CITY PLANNING COMMISSION

- APPLICATION:
- A. Negative Declaration
 - B. Rezone from R-3 (PC) PUD to R-3A (PC) PUD Zone
 - C. Special Permit modification to add 22 units to an apartment complex in the Campus Commons PUD (Westbridge PUD)
 - D. Campus Commons PUD Schematic Plan Amendment from Student Apartments to Apartments

LOCATION: 1255 University Avenue

P87-014

EXHIBIT B-1

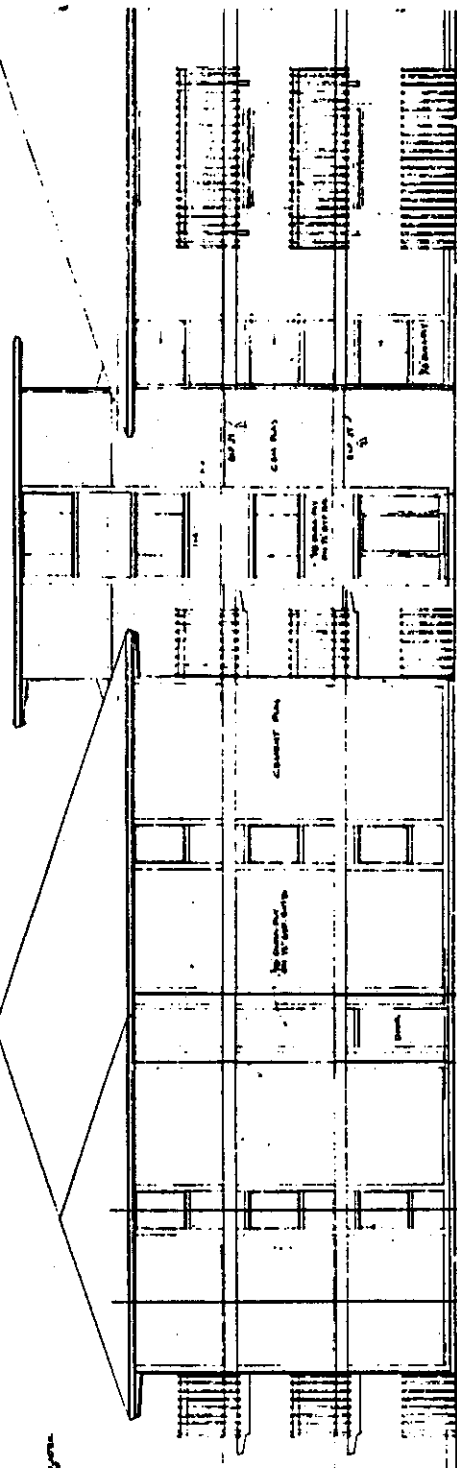
The apartment complex is located at the center of the subject site with a 117-space parking lot on the east side of the parcel and a 78-space parking lot on the west side of the parcel (Exhibit A). The parking lots are screened from University Avenue by a hedge and large bushes are planted along the levee adjacent to the east parking lot. A trash dumpster is located in each parking lot. Recreational amenities at the site include a pool, spa, steam room, weight room, and recreation center with video games, pool table and ping-pong table. Concrete slabs with indentations for bicycles are provided along the east and west sides of the complex; however, there are no provisions for locking the bicycles to anything that is secured and subsequently, the bicycle spaces are not used. One freestanding metal bicycle rack is also provided.

In order to screen the parking lots from the American River Parkway corridor, staff recommends that screening bushes be planted along the southern property line of the western parking lot. A screening bush has been cut down along the levee adjacent to the east parking lot; this bush should also be replaced. Staff also recommends that solid masonry trash enclosures be constructed in the east and west parking lots in order to screen the existing dumpsters from the parkway corridor and enhance the aesthetics of the site. The enclosures should follow the guidelines outlined in Exhibit E.

The existing 195 parking spaces will meet the Zoning Ordinance requirements of 1.5 spaces per dwelling unit and one additional guest space for every 15 units. Staff inspection of the site found that while many of the students own bicycles, there does not appear to be adequate safe and secure places to park bicycles other than inside the apartment units. Staff therefore recommends that a minimum of 10 Class I bicycle parking spaces be provided and that nine spaces be provided which meet Class

19 Studio Units
4 Large Studio Units
19 1 Bedroom Units
81 2 Bedroom Units
2. A landscape plan indicating screening bushes along the south property line between the levee and the east and west parking lots shall be submitted to the Planning Director for review and approval. The additional landscaping shall be installed within four months of the date of special permit modification approval (by May 8, 1987).
3. The applicant shall construct trash enclosures for the two existing trash dumpsters in the east and west parking lots within four months of special permit modification approval (May 8, 1987). The trash enclosures shall be constructed per the guidelines outlined in Exhibit E.
4. A minimum of 10 Class I bicycle parking spaces and nine Class II/III bicycle parking spaces shall be provided on-site within four months of special permit modification

approval (May 8, 1987). The location of the bicycle parking spaces shall be subject to Planning Director review and approval.

EXHIBIT D-1
ACTUAL UNIT CONFIGURATION

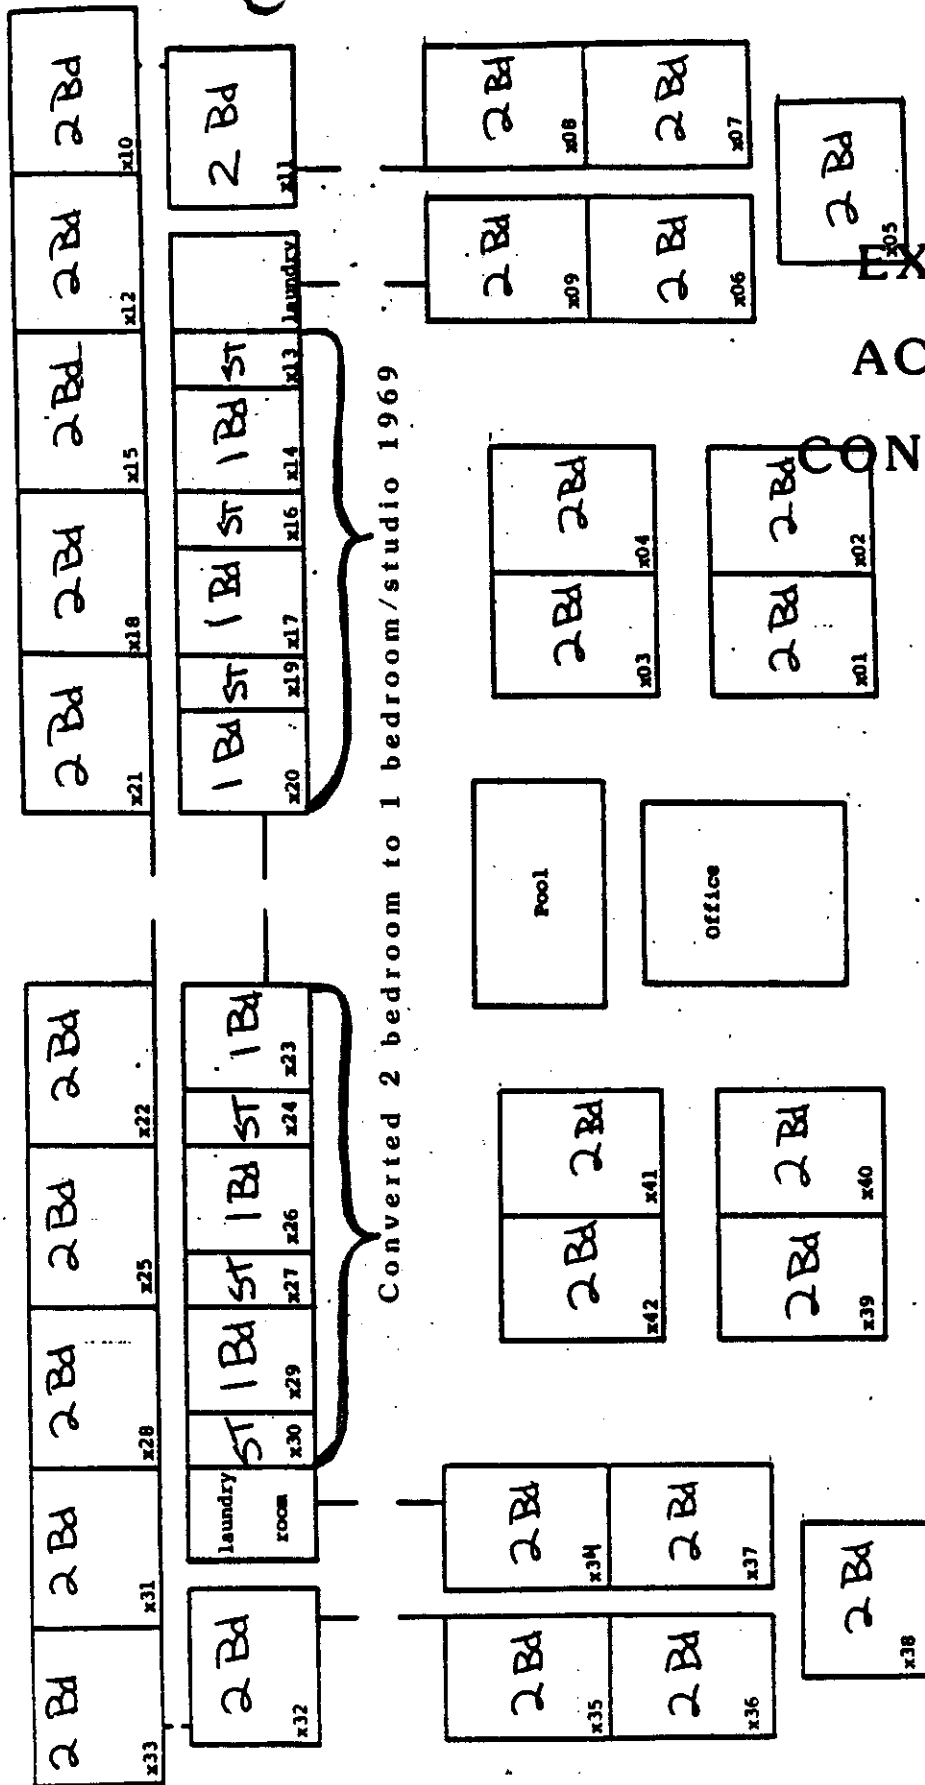
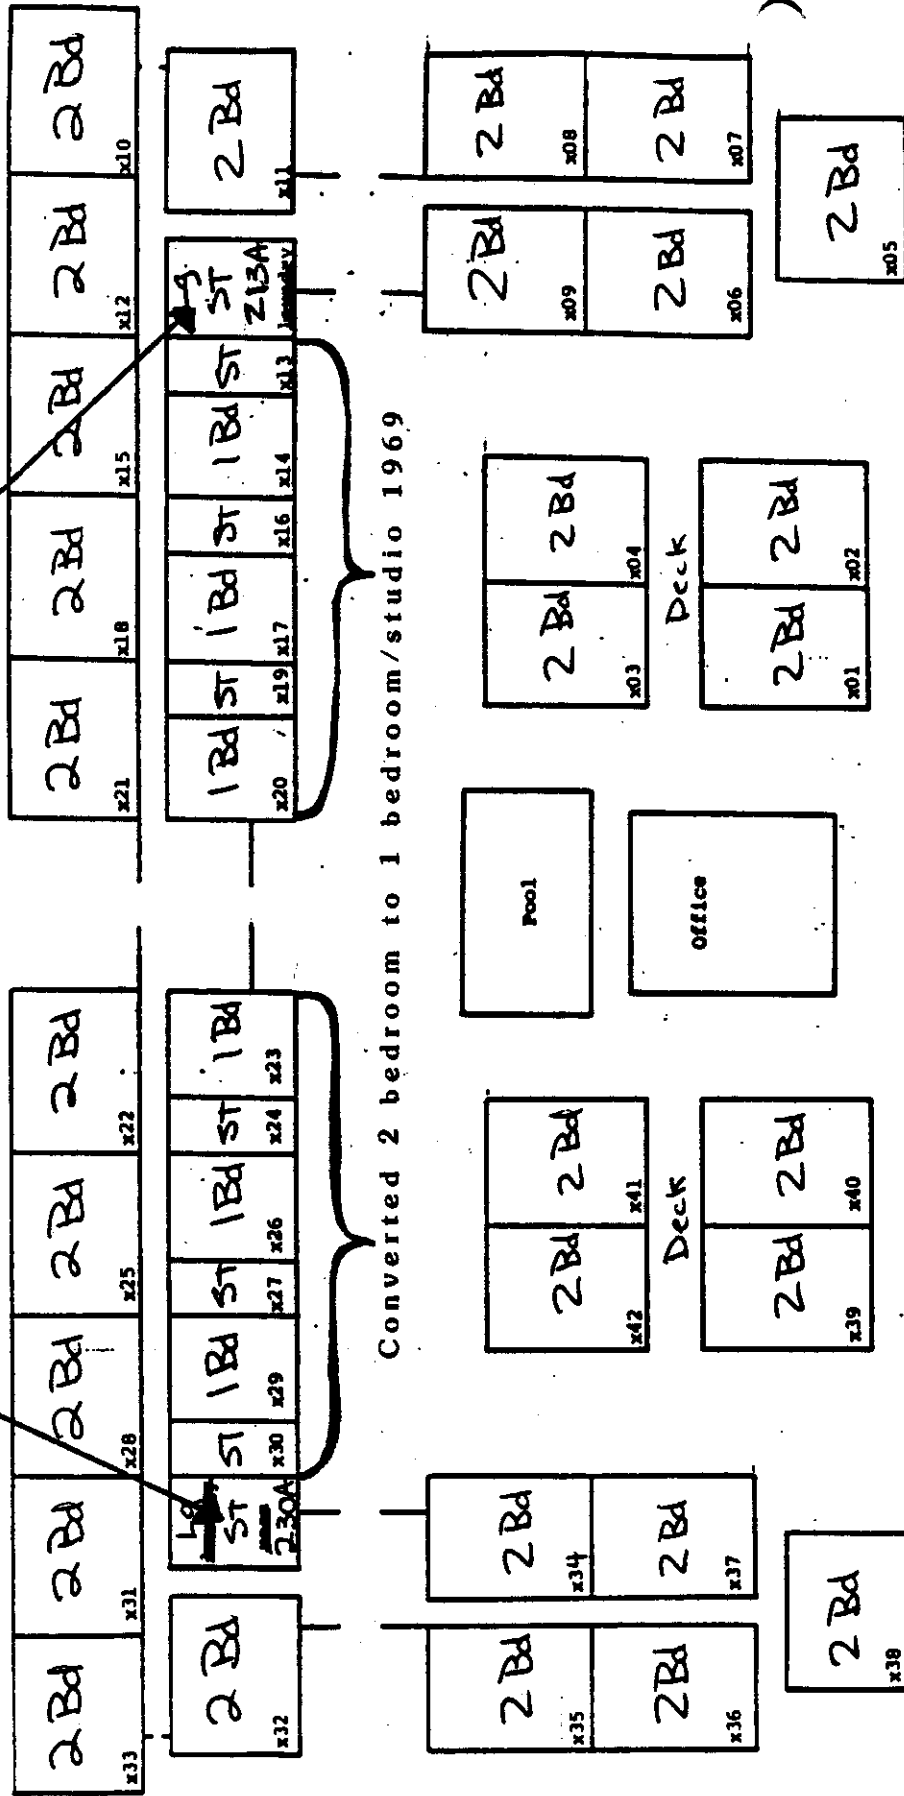
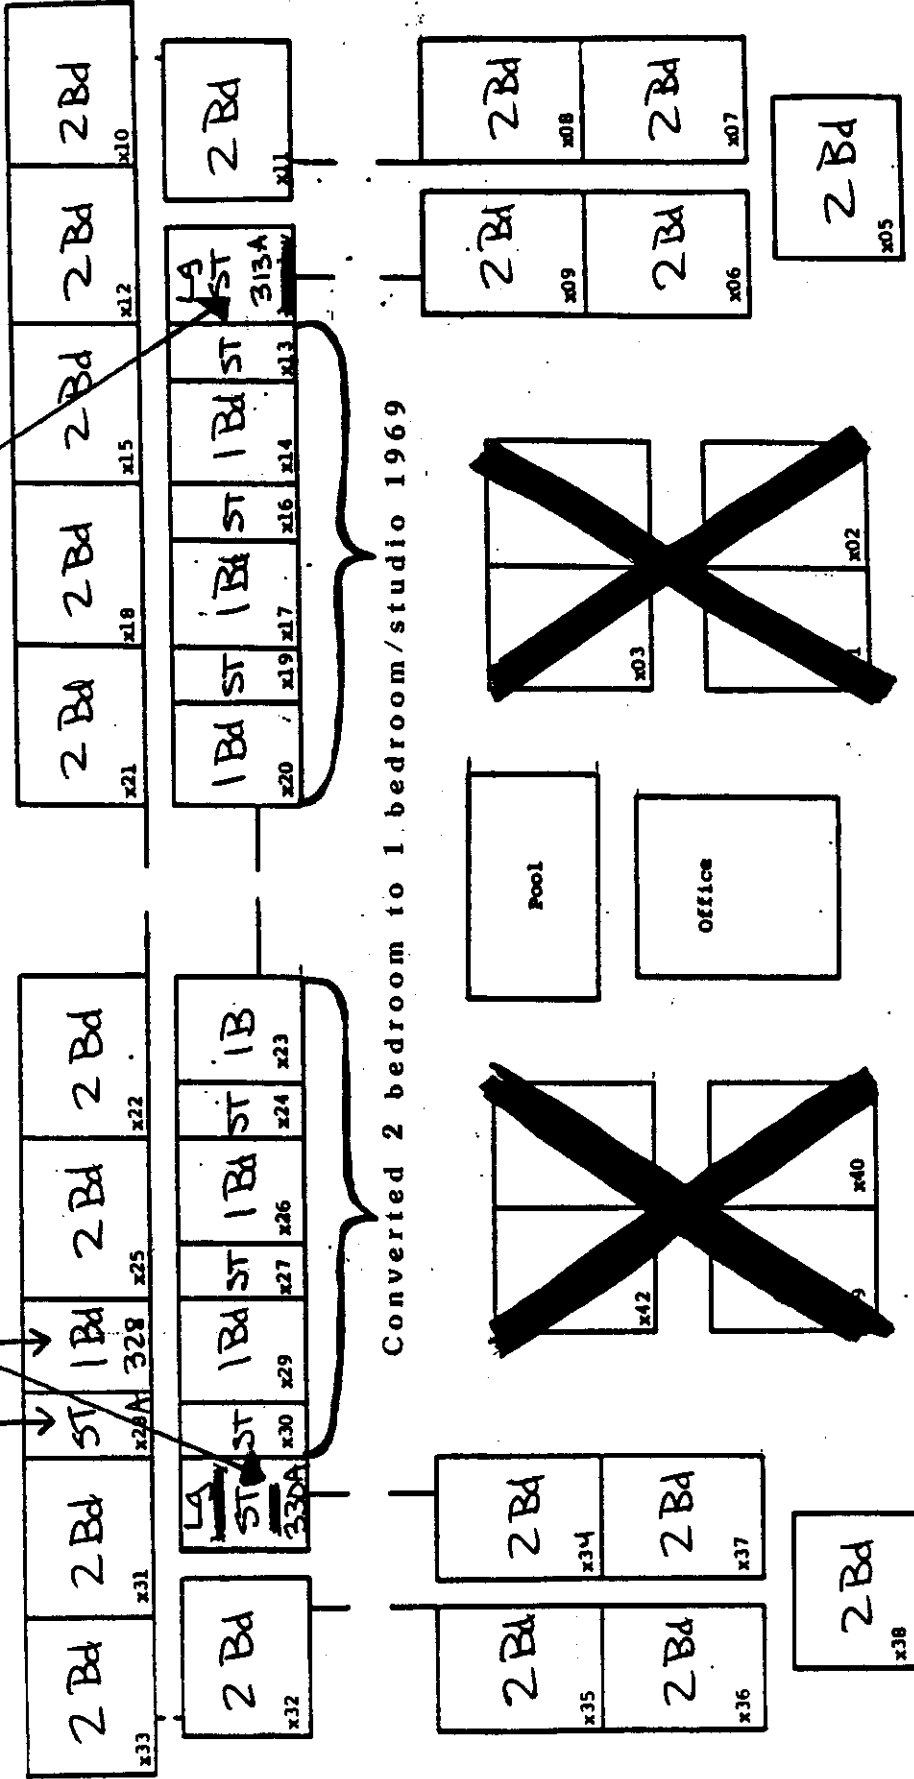
In 1969, however, building permits were issued for a 119 unit apartment complex. While the exterior site plans and elevations remained the same, 19 two-bedroom units were converted to one bedroom and studio units resulting in the net increase of 18 units (the manager's office was originally approved to a manager's dwelling unit; however, this was not constructed) (Exhibit D). No record of a special permit modification to permit this increase in density has been found.

In 1980, building permits were issued to convert four TV rooms in the apartment complex to four large studio apartments (Exhibit D). This increased the number of dwelling units on the site to 123, for a density of 35 dwelling units per acre. This density exceeds the allowed density of the R-3 Zone. Neither special permit modification nor rezoning was requested to allow this increase in density.

The applicant is requesting a rezoning to R-3A (PC) PUD and a special permit modification to allow the existing 123 units on the site to remain and be legally conforming with City Zoning Ordinance requirements. As noted above, 18 of the additional units have been in existence since 1969, and the four large studios have been in existence since 1980. The approved and existing unit counts are as follows:

1. The apartment modification shall be limited to 123 units consisting of the following unit types:
